NRC Resolution of Post-Exam Comments
2016 Beaver Valley Unit 1 Initial Exam

Question 35

BRG Oil Drain Temperatures

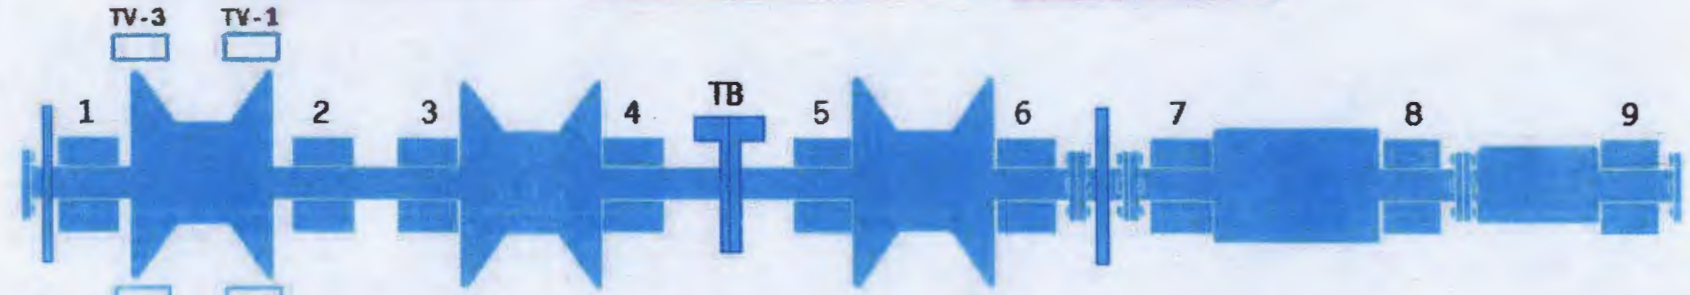
Per operator rounds data taken on 11/16/16 at 0800 (attached), the difference between Turbine Lube Oil Cooler Outlet temperature (119.9°F) and Turbine Bearing Oil return temperatures, ranged between 22.1°F (142°F return temp) and 34.1°F (154°F return temp), with an average of 29.7°F. All of which, if added to Answer 'B' Turbine Lube Oil Cooler Outlet temperature of 177°F results in Turbine Bearing Oil return temperatures exceeding trip criteria.

Additional supporting data was obtained by conducting Beaver Valley Simulator scenarios with a Loss of Secondary Component Cooling Water. When Turbine Lube Oil Cooler temperature was allowed to rise to 177°F, all Turbine Bearing Oil return temperatures exceeded trip criteria of 195°F. (See Attached)

Based on the above information the facility recommends accepting two answers for question 35, the original correct answer "A", and answer "B".
